COMPANY NAME	West Coast Regional Council
ATTENTION	Tony Ridge
SUBJECT	Review of TiGa resource consent application – Barrytown Mine

The WCRC commissioned Wallbridge Gilbert Aztec (WGA) to review the technical documents lodged in support of the application. The review by WGA covered the hydrological and hydrogeological aspects of the application. Ecological, geotechnical, water quality and other aspects of the application were considered only in regard to identifying aspects of the site and surrounding area that may be impacted by changes in the hydrological system. The WGA review was documented in a memorandum to WCRC dated 4 July 2023¹.

A series of requests for information were raised in the WGA (2023) memorandum. Responses to these requests have been provided by the applicant. WGA's review of the responses is provided below. This document should be read in conjunction with the earlier memorandum (WGA 2023). The objective of this review is to determine if there are any remaining gaps in technical information provided by the applicant in support of the resource consent application.

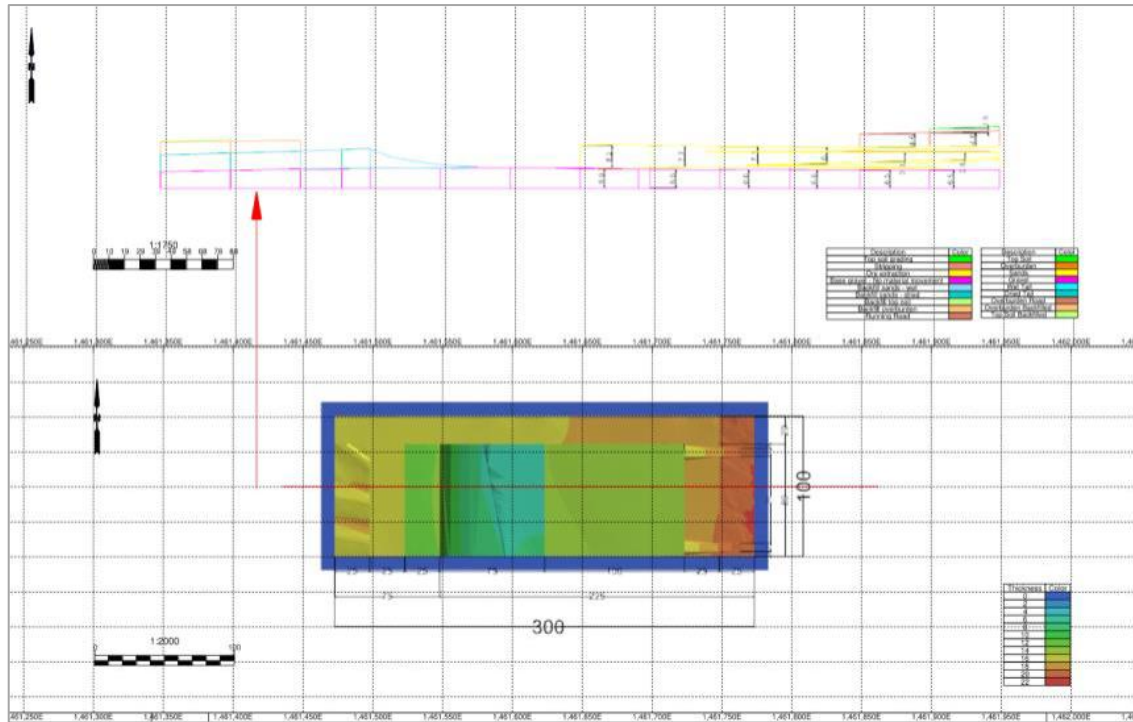
- 5. Please also confirm the aquifer parameters applied to the units simulated in the stability analysis. If the hydraulic conductivity applied to the basal gravel unit is not in accordance with the values provided in the Hydrology report, please adjust the value applied in the geotechnical model accordingly.**

Hydraulic Conductivity of Barren Gravel Base updated to 1×10^{-3} m/s and applied to stability analysis (attached).

Final report will include revised results.

Thank you. No further information required.

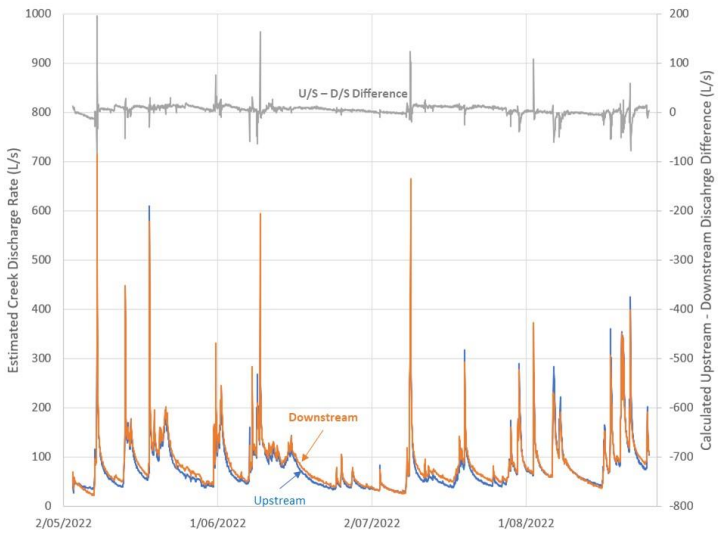
4. 2	Please provide a map identifying the locations of both flow monitoring sites	Written response
4.2 Response	<p>The flow sites are located on Collins Creek. The upstream site is immediately upstream of the SH6 bridge and called Collins Upstream or Colins U/S. The downstream site is located at the farm lane ford across Collins Creek and called Collins Downstream or Collins D/S.</p> <p>Thank you. No further information required.</p>	<p>File: 4-2_CollinsCk_Flowsites.PDF</p>

Hydraulic Conductivity Zonation in Layer 1

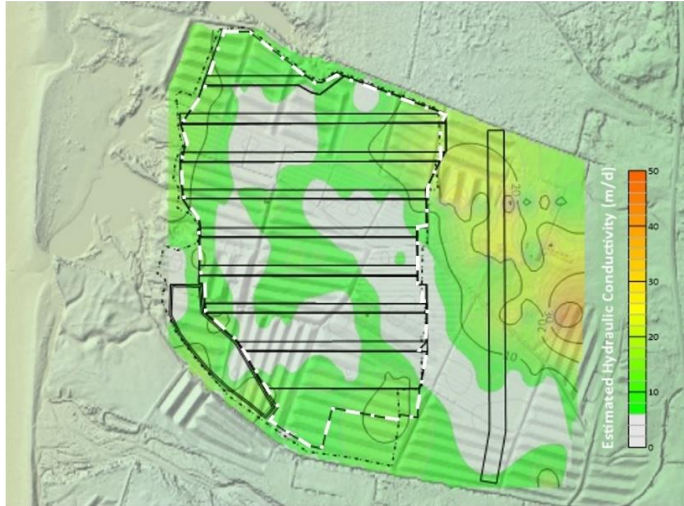
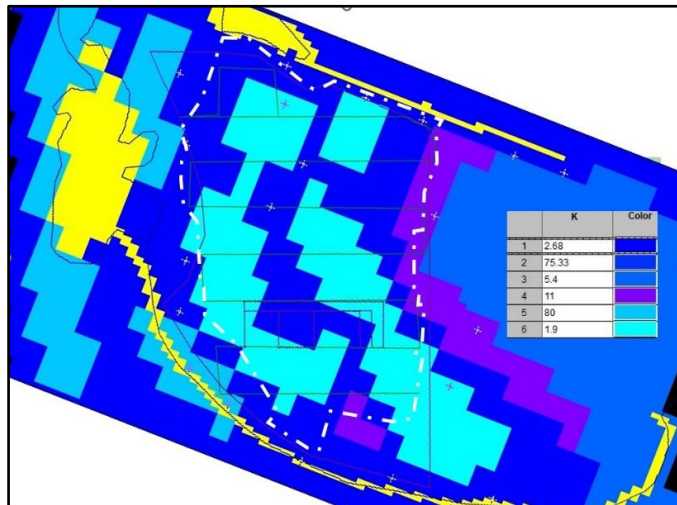
Please provide the layout of the parameter zones listed in Table 22 within the refined model mesh area.

As outlined in other parts of the report describing groundwater flow model set-up, five zones of hydraulic conductivity in the superficial model Layer 1.

Zone 3 relates to the Eastern Gravel Overburden deposit the does not extend into the sand extraction area. Zone 4 is a fringing halo of the Eastern Gravel Overburden that was found in optimisation to be more permeable. Zone 5 a high permeability zone suggested by optimisation. It is distributed around the coastal lagoon margins and section of middle Collins Creek. Zone 6 is correlated with the low permeability mineral sand, which is a fine sand considered to have hydraulic conductivity of 3 m/d or less. Zone 1 and Zone 6 are adjacent in terms of hydraulic conductivity and physical distribution. The two figures below show the progression from hydro stratigraphic modelling outlined in section 2.6.6 of the assessment report.

Panel 8: Layer 1 (above) and Layer 2 (below)

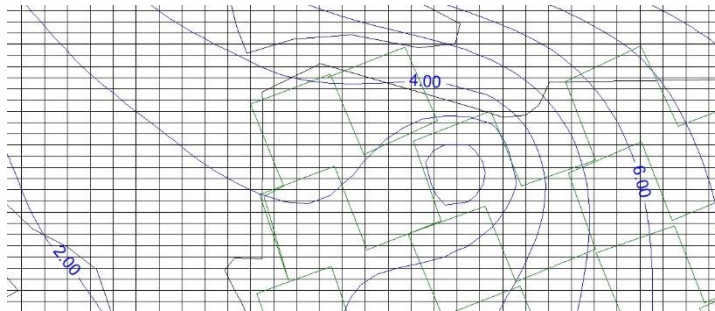
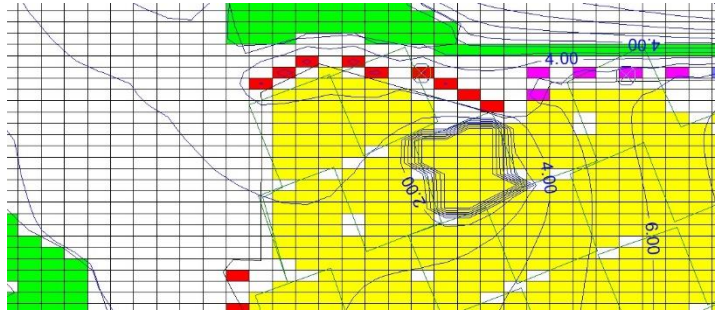
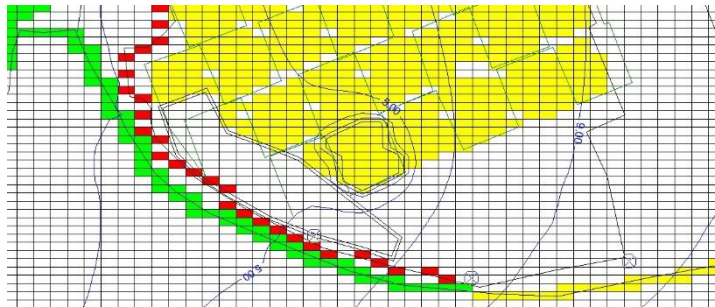
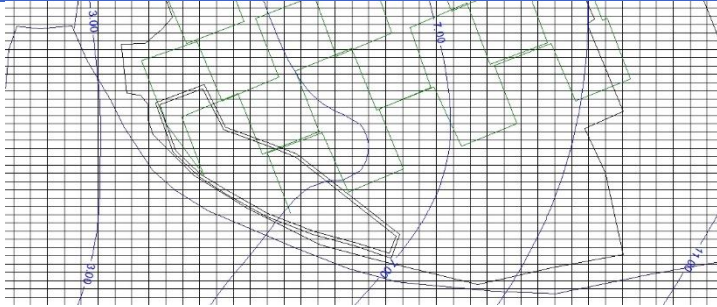
<p>4. 21</p>	<p>Please provide indicative groundwater drawdown maps showing the extent of drawdown when ore extraction is operational in Panel 8 and separately when Panel 9 is operational. Please present the drawdown maps for Layer 1 and Layer 2, together with an overlay of surface water bodies, wetland areas and known springs.</p>	<p>Video response</p>

Drawdown is more concentrated surrounding the respective active sand extraction areas in the superficial Layer 1 than deeper Layer 2.

The northern panel induced a deeper and greater drawdown compared to the southern panel.

The simulated groundwater levels are accepted. It appears that not all of the groundwater level contours for the center of the pit in Panel 1 Layer 1 may be presented in the relevant image. However, the general extent of groundwater drawdown is indicated. The drawdowns presented take into account the operation of the proposed groundwater recharge systems. i.e. They represent mitigated effects scenarios.

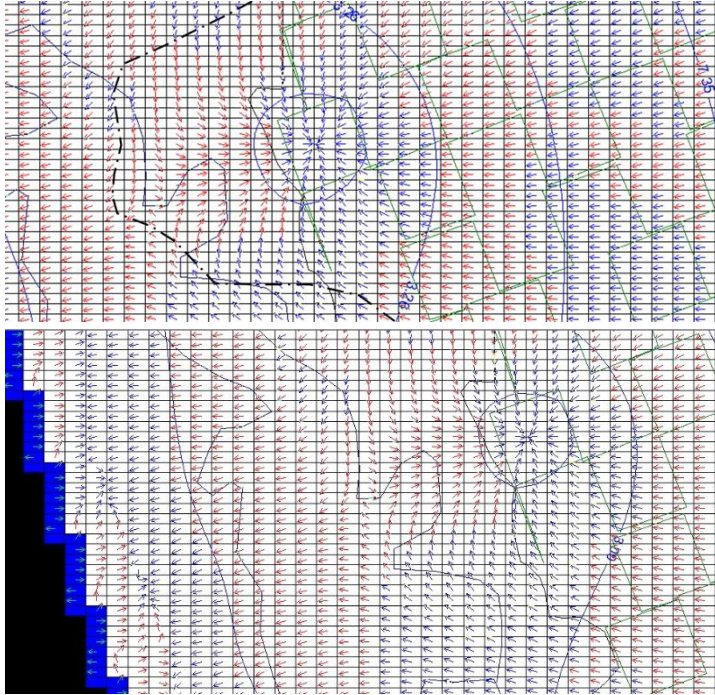
Please provide model outputs for water losses from adjacent surface water bodies to the mine and compare these to inflow and outflow rates for the surface water bodies in the calibration model.

Note that the vertical axis in the chart shown is not in units of m³/day but rather L/s.
Thank you. No further information required.
